ECE/TRANS/WP.29/GRE/2006/9
26 January 2006

World Forum for Harmonization of Vehicle Regulations (WP.29)

PROPOSAL FOR DRAFT AMENDMENTS TO REGULATION No. 98

(Headlamps with gas-discharge light sources)

Figure 1

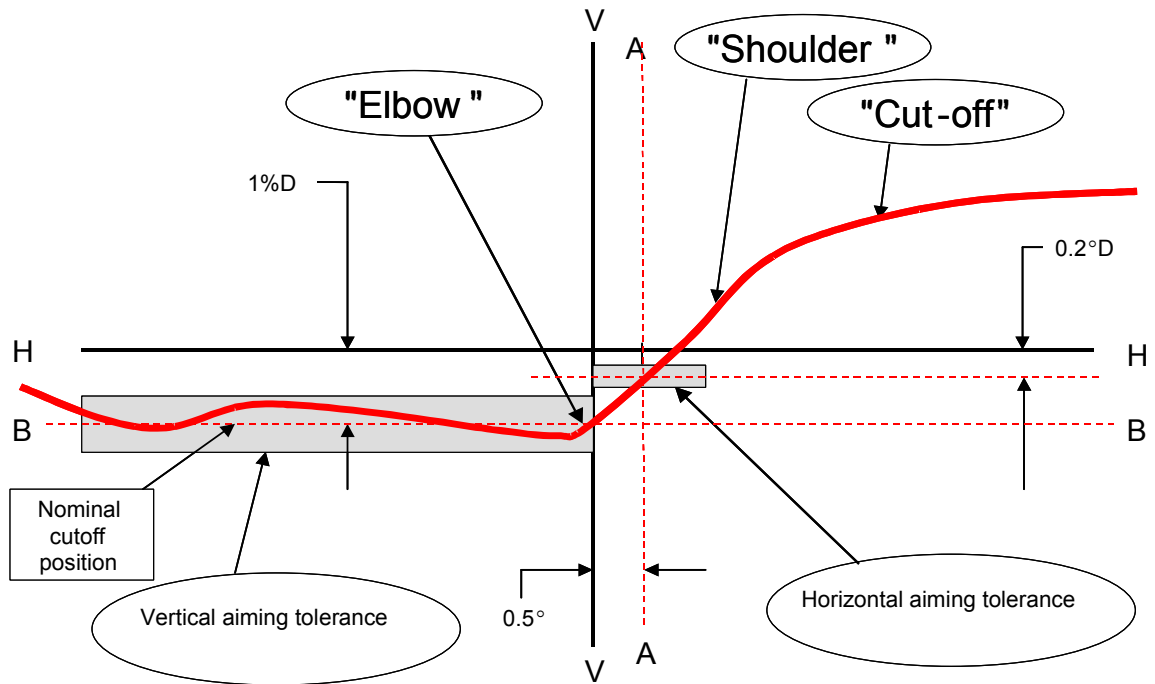
"6.2.1. **The luminous intensity distribution of the passing beam headlamp shall incorporate a "cut-off" (see Figure 1 below), which enables the headlamp to be adjusted correctly for the photometric measurements and for the aiming on the vehicle.**

6.2.2. **The headlamp shall be visually aimed by means of the "cut-off" (see Figure 1 below) as follows:**

6.2.2.1. **for vertical adjustment: the horizontal part of the "cut-off" is moved upward from below line B and adjusted to its nominal position one per cent (25 cm) below the H-H line;**

6.2.2.2. for horizontal adjustment: the "elbow-shoulder" part of the "cut-off" shall be moved:

- for right hand traffic from right to left and shall be horizontally positioned after its movement so that:
- above the line $0.2^\circ D$ its "shoulder" shall not exceed the line A to the left and
- on the the line $0.2^\circ D$ or below its "shoulder" should cross the line A and
- the kink of "elbow" should be primarily on the V-V line;

Figure 1: Measurement of "cut-off" quality

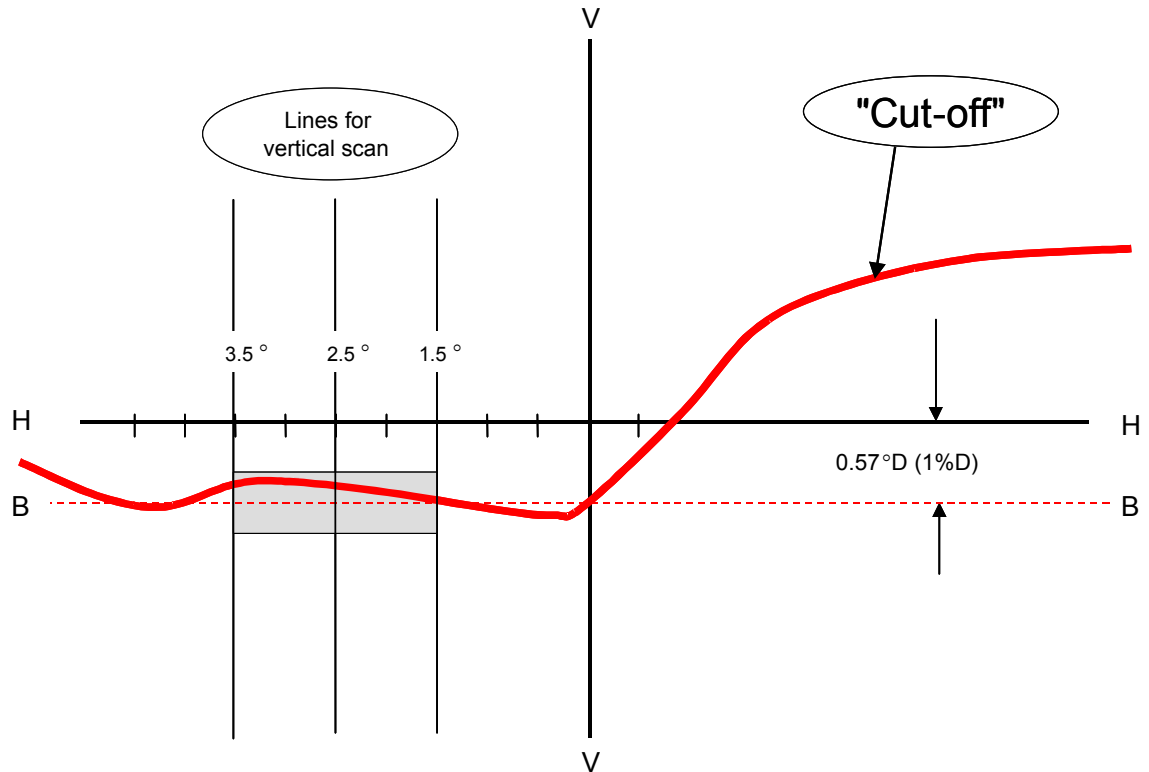
The part of the horizontal "cut-off" that serves for vertical adjustment shall be horizontal between 1.5° and 3.5° from the V-V line (see Figure 1 below).

- The inflection points of the "cut-off" gradient at the vertical lines at 1.5°, 2.5° and 3.5° shall be determined by the equation:

- The maximum vertical distance between the inflection points determined shall not exceed 0.2 °.

Figure 2: Instrumental vertical and horizontal adjustment- horizontal line scan method

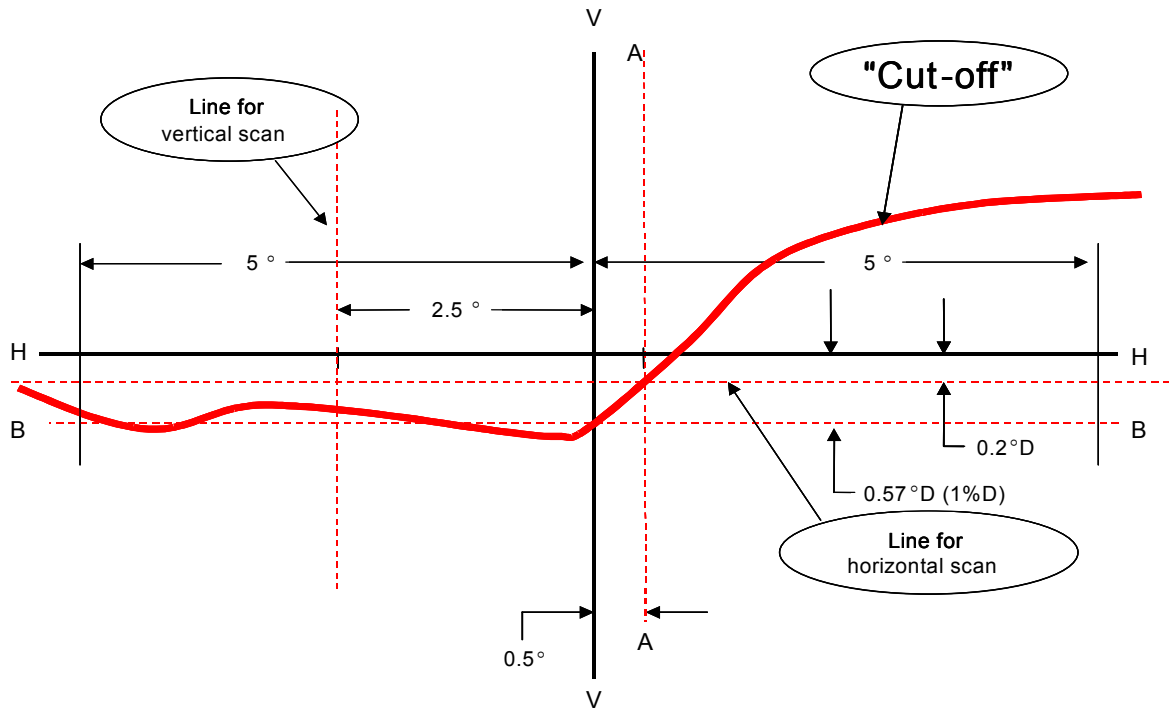
Moving upward from below the line B (see Figure 2 below), a vertical scan is carried out through the horizontal part of the "cut-off" at 2.5° from V-V. The inflection point (where $d^2(\log E) / dv^2 = 0$) is determined and positioned on the line B situated one per cent below H-H.

(a) The "0.2 D line" method (see Figure 2 below).

A single horizontal line at 0.2° D shall be scanned from 5° left to 5° right after the lamp has been aimed vertically. The maximum gradient "G"

determined using the formula $G = (\log E_{\beta} - \log E_{(\beta + 0.1^{\circ})})$ where β is the horizontal position in degrees, shall not be less than 0.08.

The inflection point found on the 0.2 D line shall be positioned on the line A.

Figure 3: Instrumental vertical and horizontal adjustment-three line scan method

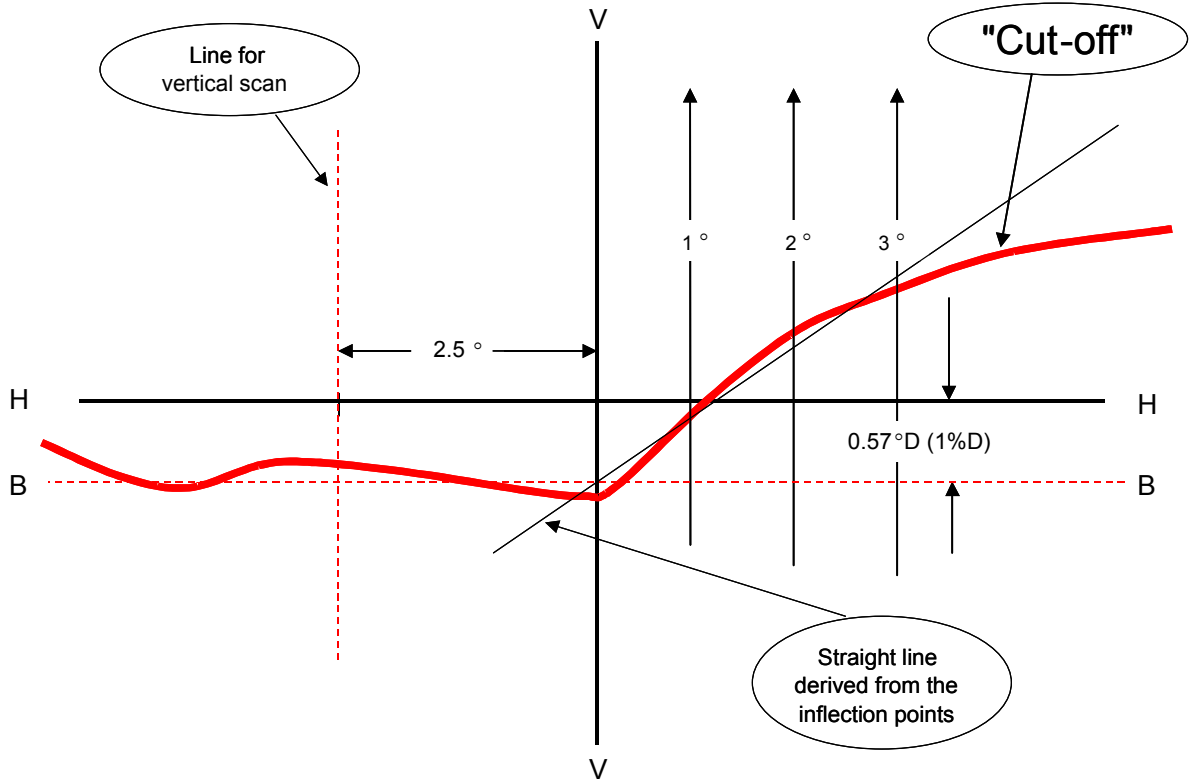
(b) The "3 line" method (see Figure 3 below)

Three vertical lines shall be scanned from $2^{\circ} D$ to $2^{\circ} U$ at $1^{\circ} R$, $2^{\circ} R$, and $3^{\circ} R$ after the lamp has been aimed vertically. The respective maximum gradients "G" determined using the formula:

where β is the vertical position in degrees, shall not be less than 0.08. The inflection points found on the three lines shall be used to derive a straight line. The intersection of this line and the line B found while performing vertical aim shall be placed on the V line.
